Model type:
AVL105EX

Commercial code:
F029844

Notices

n1040325: New shock absorber fixing system with pin

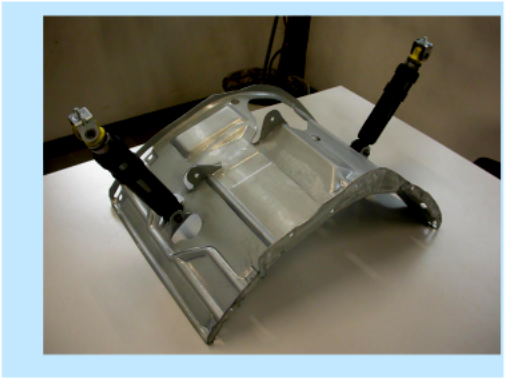
From serial no. 40427.0001, shock absorbers have been fixed to the tank unit cradle with two 11 mm pins code C00110163 (see fig. 01 and 02 enclosed) in place of the 8 mm screws code 093750 and relevant locking nuts code 030443, on all washing

machines and dryers produced in the Comunanza factory.
The items affected by this modification are:
1) The cradles have the same Service code, as they can be used in place of the new ones after widening the shock absorber fixing holes to a diameter of 10 mm.
Code 093848 - Tank unit cradle 46 lt
Code 093878 - Tank unit cradle 40 lt.
2) The new shock absorbers, with fixing bushing having no s/steel spacer, are not managed as they are interchangeable with the premodified items (make sure they are CIMA type, as the managed items), fixed with M8 screws code 093750 and related locking nut code 030443 (see figs. 05 and 06).
Code 093884 - Shock absorber 80 N
Code 093885 - Shock absorber 100 N

To remove the shock absorber from the tank, first extract the pin with a few hammer taps (see fig.03) until it is aligned with the tank bracket and then pull it out with a pair of pliers (see fig. 04).
(To refit the shock absorber use a new pin. Insert the pin until the toroidal edge is aligned with the bracket.)

Fig. n10402231

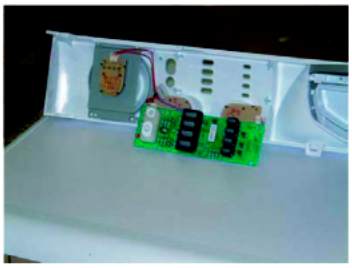
From serial no. 40429.0001, models AVL, AVXL, AVSL, AML have been equipped with a new panel with well holes for the ON/OFF and RESET buttons and flush plastic light diffusers in place of the projecting siliconed ones (see picture n10402231

Fig. n10402232

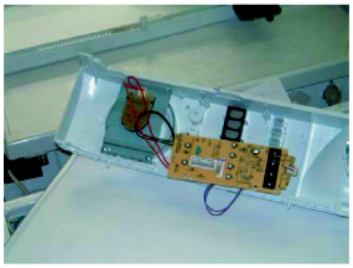
Fig.02). These features determine whether an appliance is modified or premodification.
The modification has also involved the electronic card whose panel and display communication connectors are on the left and not at the back (see picture n10402232 Fig.2).

Fig . 001

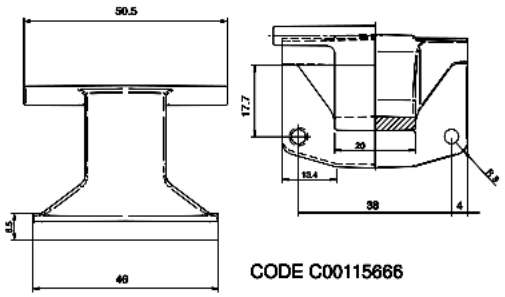
From serial no. 50207.0001, all Ariston models produced in the Teverola factory (see table 001 attached) with industrial code (given on the rating plate) starting with 46, have been equipped with a Zamac hinge with 150° opening angle, code C00115666 (see Fig.001).
This modification has involved the introduction of the following items:

Code C00115670 - Complete door EVOII 150° white 27 with standard glass;
Code C00115674 - Complete door EVOII 150° white 27 with long glass;
Code C00115667 - EVOII body for 150° hinge white 27;

The premodified items are not interchangeable separately with the modified ones.

Code C00110133 - Complete door EVOII Standard 180° white 27 standard glass;
Code C00092157 - Complete door EVOII 180° white 27 long glass;
Code C00096193 - EVOII body for 150° hinge white 27;
